## Technical Bulletin No. 140

## Anode Update

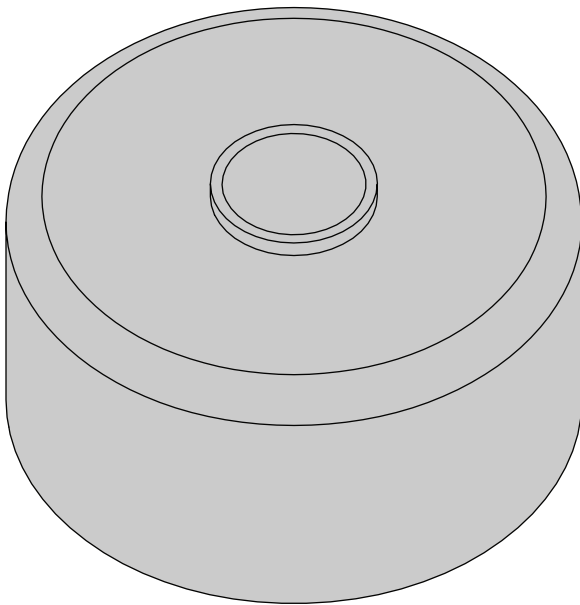
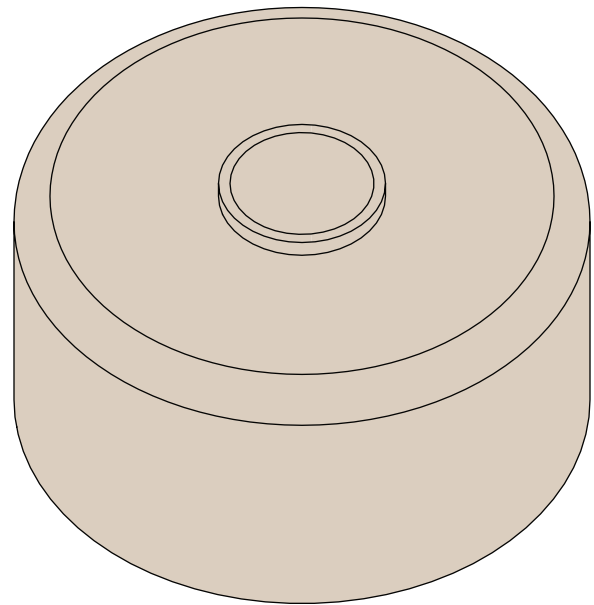
In 2020, the optional zinc anode was replaced by an interchangeable magnesium anode. The anodes share the same dimensions, but magnesium was found to be more efficient in preventing pump corrosion in fresh water applications.
